# HISTORIC AND DESIGN REVIEW COMMISSION

**HDRC CASE NO:** 2024-160  
**ADDRESS:** 227 W WOODLAWN AVE  
**LEGAL DESCRIPTION:** NCB 1838 BLK 14 LOT 23 LAUREL HEIGHTS UNITED METHODIST CHURCH SUBD  
**ZONING:** R-4, H  
**CITY COUNCIL DIST.:** 1  
**DISTRICT:** Monte Vista Historic District  
**APPLICANT:** Mike McGlone/Alamo Architects  
**OWNER:** LAUREL HEIGHTS UNITED METHODIST CHURCH  
**TYPE OF WORK:** Installation of gates, window grilles, and handrails  
**APPLICATION RECEIVED:** April 03, 2024  
**60-DAY REVIEW:** June 02, 2024  
**CASE MANAGER:** Jessica Anderson

# LOGGIA SECURITY

TYPICAL ARCADE BAY (3)

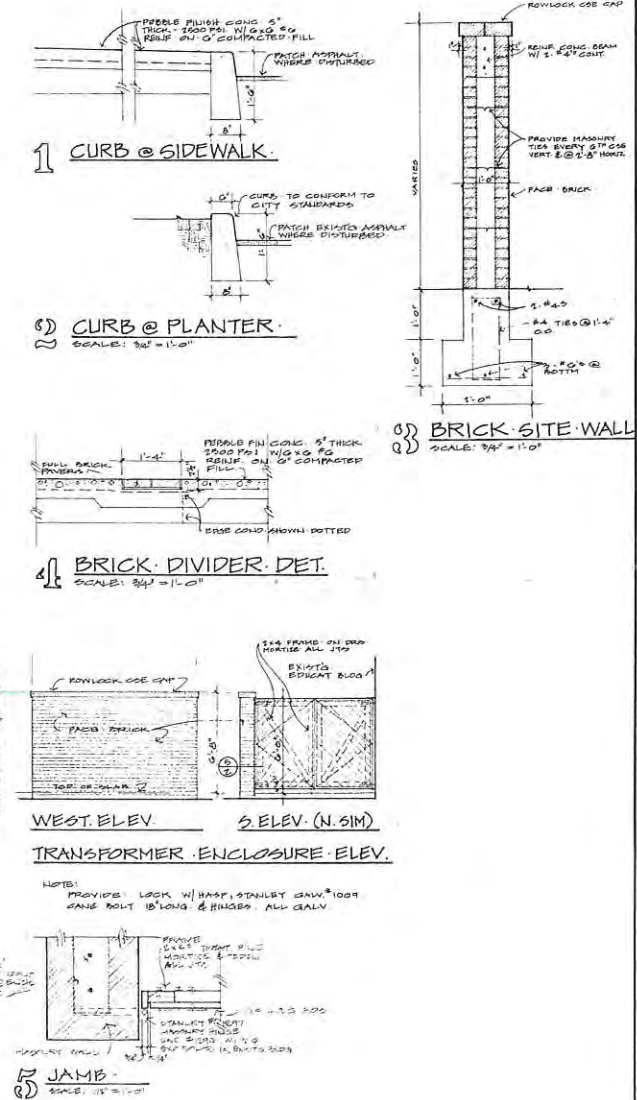
- c. GRILLES: The applicant requests to install three metal grilles in the openings of the south loggia. Historic Design Guidelines for Exterior Maintenance and Alterations 7.B.i says approved screen panels should be simple in design as to not change the character of the structure or the historic fabric. Staff finds the request generally appropriate, but that the grilles should be installed via mortar to avoid damage to historic masonry.

- i. That the gates and grilles be inset and installed via mortar to avoid damage to historic masonry, as noted in findings b and c.

MAIN TOWER ELEVATION  $\frac{1}{2}'' = 1'-0''$   
 LAUREL HEIGHTS VMC 3/29/2024

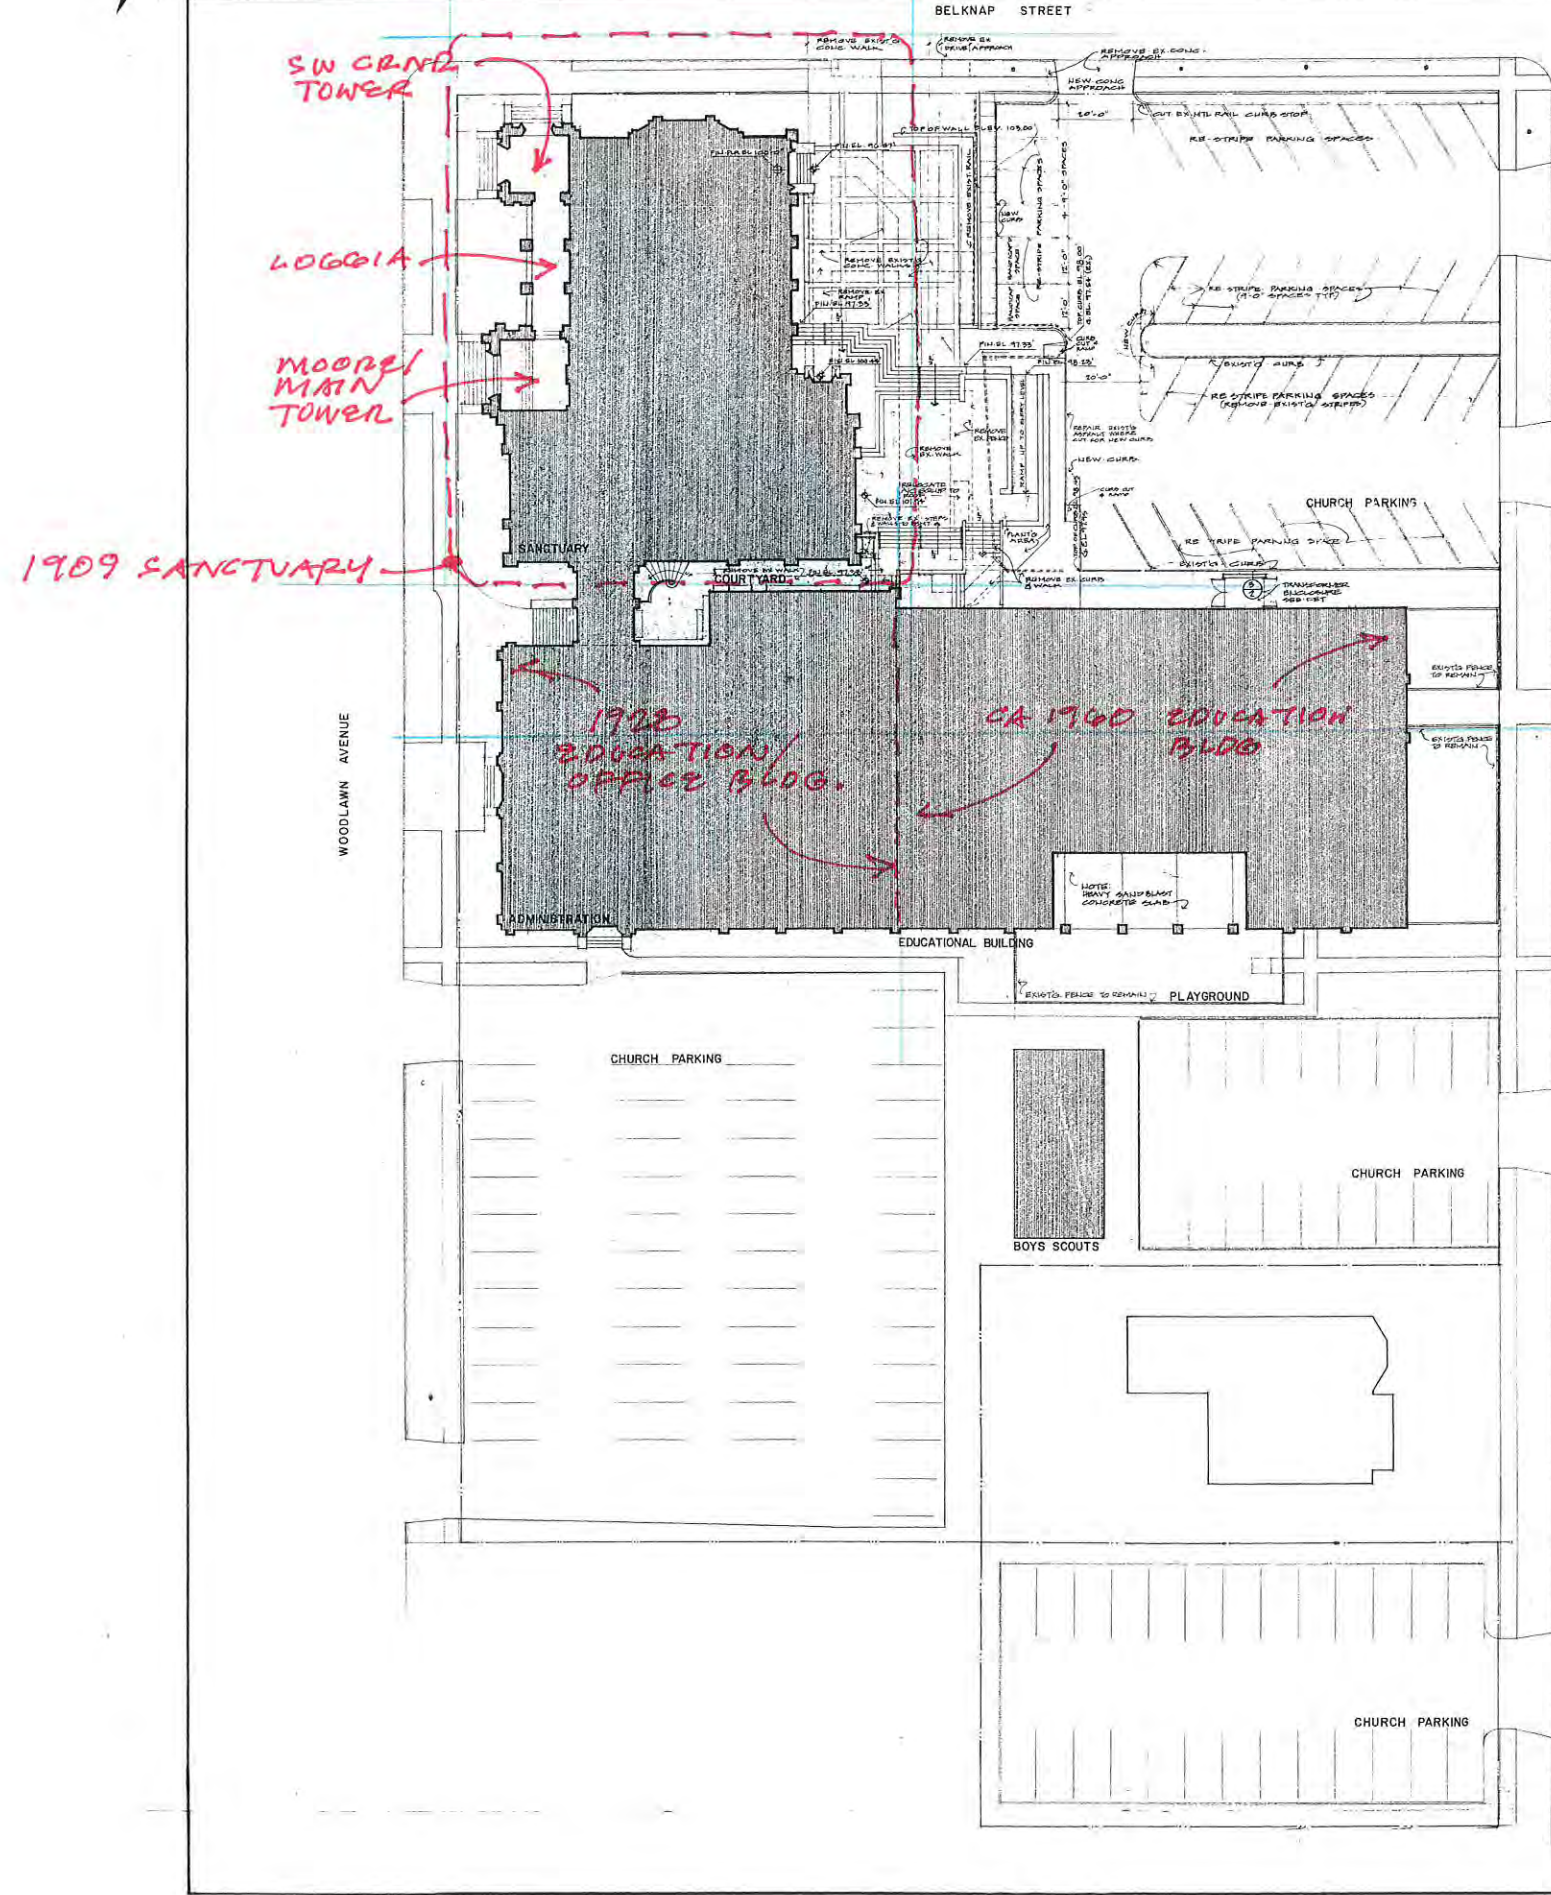
- b. GATES: The applicant requests to install three metal gates at the entrances on the southwest corner of the building and at the south tower. The gates fill approx. 2/3 of each archway. Historic Design Guidelines for Exterior Maintenance and Alterations 7.B.i says approved screen panels should be simple in design as to not change the character of the structure or the historic fabric. Staff finds the request generally appropriate, but that the gates should be installed via mortar to avoid damage to historic masonry.
